STATE OF NORTH CAROLINA
DEPARTMENT OF TRANSPORTATION

Addendum No. 1
RE: Contract # C204039
WBS # 34243.3.2
STATE FUNDED
Polk County (I-4729A)
I-26/US-74/NC-108 Interchange Modifications in the Town Of Columbus

September 19, 2017 Letting

The following revisions have been made to the Roadway plans:

0 5 10
PROJ. REFERENCE NO.
I-4729A
SHEET NO.
X-86
6/23/16
1080
1070
1060
1050
0.043
1082.33
41+50.00
0.066
1079.76
41+00.00
0.077
1077.15
40+50.00
-E_CONN_REV-
17-AUG-2017 10:15
J:\I-4729A\Roadway\XSC\I-4729A_Rdy_xpl.dgn
$$$$USERNAME$$$$

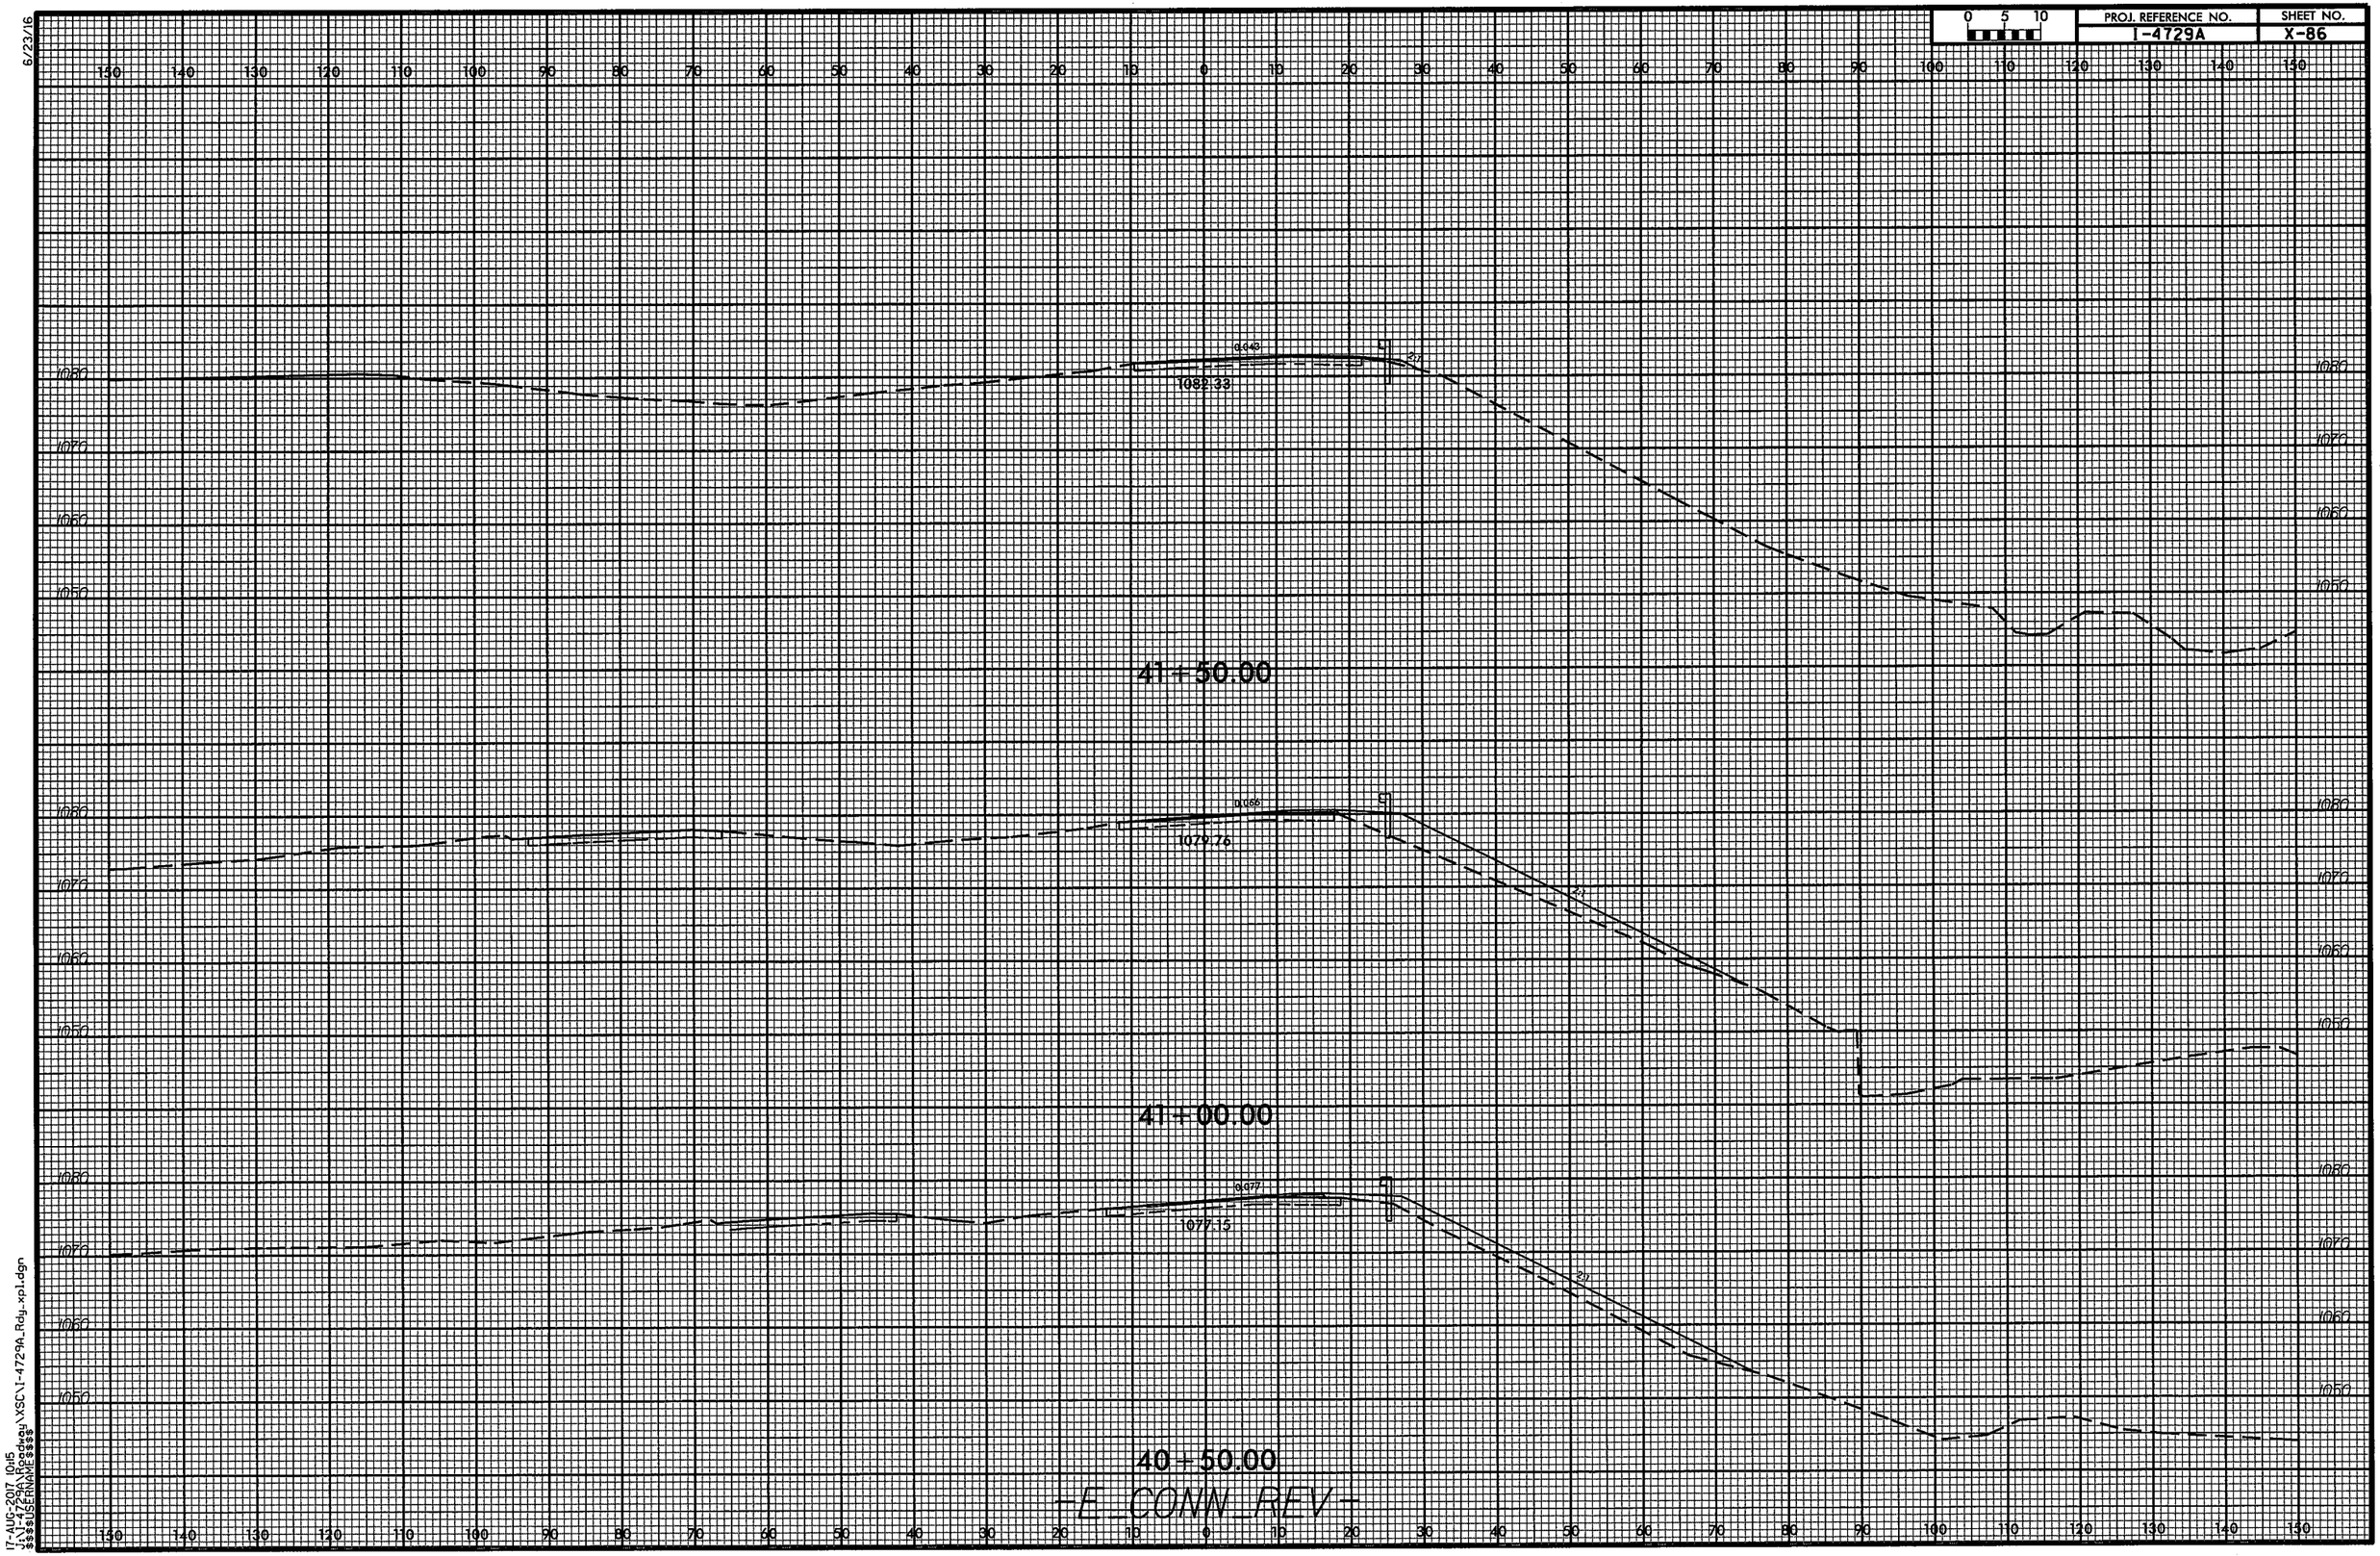
Sheet No.	Revisions
1A	Revised Index of Sheets to remove 2G-2 "Standard Embankment Monitoring Detail" and revise the number of" Drainage Summaries" sheets
2A-1, 2A-4 and 2A-5	Revised the Typical Sections for the change in mainline pavement widening design from ABC to Asphalt Base
3B-1	Revised 'Summary of Earthwork' to account for pavement widening design change
3D-1 thru 3D-4	Various drainage quantity changes as noted below
3G-1	Removed "Settlement Gauge Summary" and added note that Bridge Waiting Period only applies to Approach Slab construction
5	Revised to require Welded Steel Pipe by Trenchless method under the Interstate 26
X-1A thru X-87	Revised Cross-Sections to reflect the change in Earthwork due to the pavement design change
